Modification of Development Consent

File: SSD-7348

Modification 7

Modification Application: SSD-7348-Mod-7

Figure 1: Concept Proposal Layout (MOD 7)

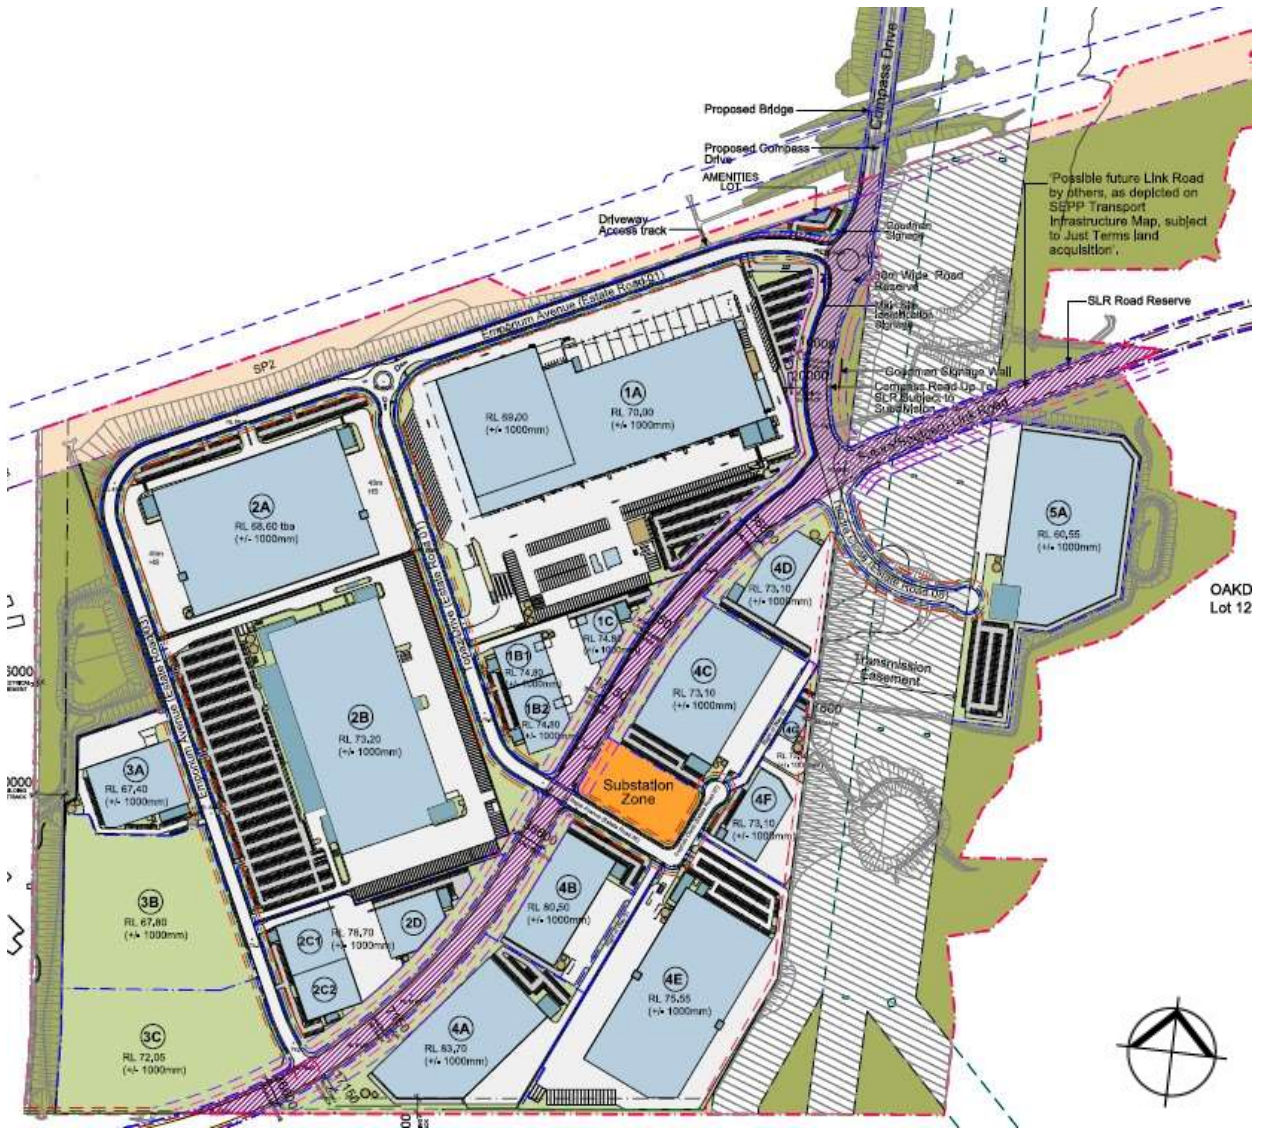
- Concept Proposal - including changes to earthworks levels and building layouts in Precinct 4, earthworks pad and lot boundary in Precinct 3 and layout of estate road 7
- Stage 1 Development – including bulk earthworks and construction of retaining walls in Precincts 3 and 4 and construction of a lot boundary fence in Precinct 1

11. Replace Figure 1 and Figure 2 in Appendix 1 with new figures as follows:
